PROPOSED CHANGES TO TECHNICAL SPECIFICATIONS 1.10, 3.6 & 4.4

CONTAINMENT ISOLATION VALVE TABLES

NEW YORK POWER AUTHORITY INDIAN POINT 3 NUCLEAR POWER PLANT DOCKET NO. 50-286 DPR-64

ATTACHMENT II TO IPN-99-010

3.6-3

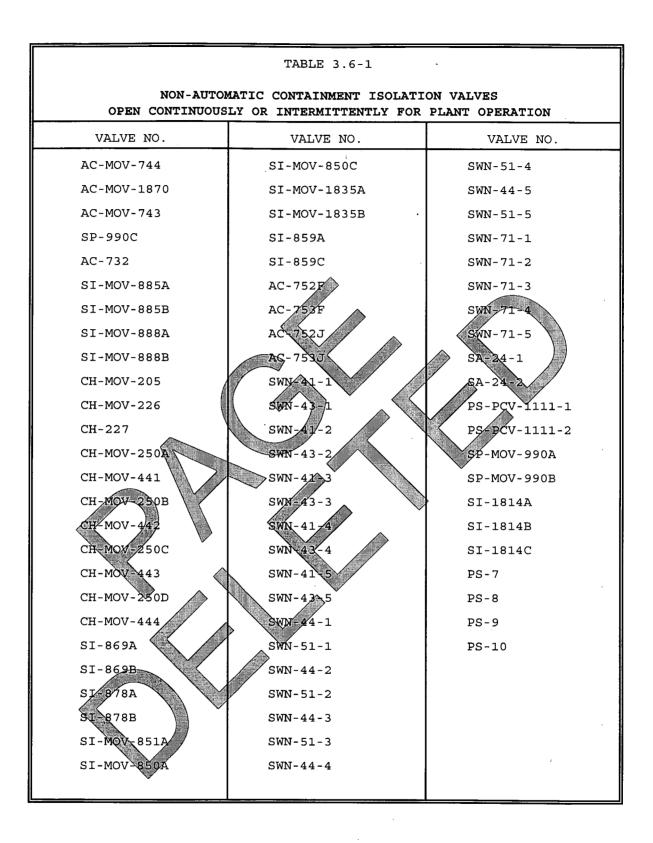
- 1. Revise Specification 1.10.1 to remove the reference to Table 3.6-1 which is in regards to non-automatic containment isolation valves (CIV) which are open continuously or intermittently for plant operations.
- 2. Revise Specification 3.6.A.1 to remove the reference to Table 3.6-1.
- 3. Revise Bases 3.6 to remove all references to Table 3.6-1.
- 4. Delete Table 3.6-1, "Non-Automatic Containment Isolation Valves Open Continuously or Intermittently for Plant Operations."
- 5. Revise Specification 4.4.E to remove the reference to Table 4.4-1.
- 6. Delete Table 4.4-1, "Containment Isolation Valves."

Table 3.6-1 lists non-automatic valves that are designated as part of the containment isolation-function.⁽⁴⁾ During periods of normal plant operations requiring containment integrity^[4], valves on this Table will be open some containment isolation valves, which include locked or sealed closed valves, may be opened either continuously or intermittently depending on requirements of the particular protection, safeguards or essential service systems. Those valves to be open intermittently are under administrative controls and are open only as long as necessary to perform their intended function. In all cases, however, the valves listed in Table 3.6-1 those containment isolation valves not required to be opened post accident are closed during the post accident period in accordance with plant procedures and consistent with requirements of the related protection, safequards, or The exception to the application of essential service systems. administrative controls are the 36 inch containment purge flow paths. Due to the size of the containment purge line penetrations and the fact that these penetrations exhaust directly from the containment atmosphere to the environment, the penetration flow path containing these valves may not be opened under administrative controls.

4.4-4

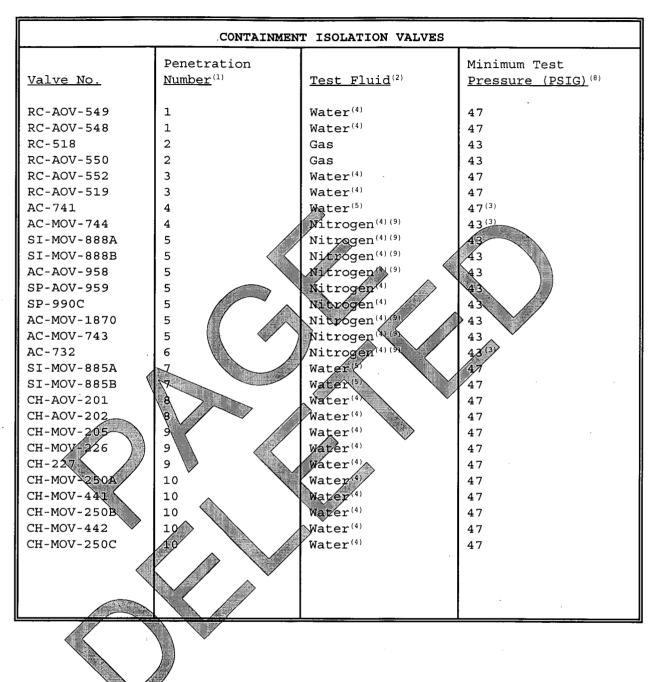
- Verify the combined leakage rate for all containment bypass leakage paths, Table 4.4 1 lists required isolation valves, (except those verified by Specifications 4.4.E.2 or 4.4.E.3) is
 ≤ 0.6La when pressurized ≥ Pa, in accordance with the Containment Leakage Rate Testing Program.
- Verify the leakage rate of water from the Isolation Valve Seal Water System is ≤ 14,700 cc/hr when pressurized ≥ 1.1 Pa, in accordance with the Containment Leakage Rate Testing Program.
- 3. Verify the leakage rate of water into the containment from isolation valves sealed with the service water system is ≤ 0.36 gpm per fan cooler unit when pressurized ≥ 1.1 Pa, in accordance with the Containment Leakage Rate Testing Program.
